PROPOSED MULTI UNIT DEVELOPMENT

B3 S16, MONCREIFF ACT

PN - SITE AND FLOOR PLAN - GROUND

Amended Plan
As Per
ACT Plan approval
& BA Approval

1 SITE PLAN - GROUND
1 : 200

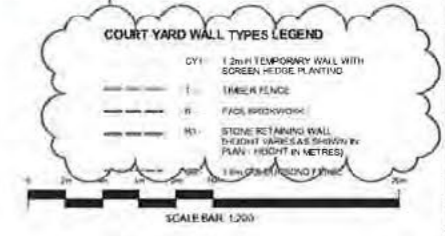
The clothes line to be relocated with the private open space and be screened from public views.

1 SITE PLAN - GROUND
 1 : 200

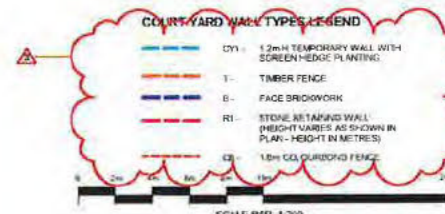
The clothes line to be relocated with the private open space and be screened from public views.
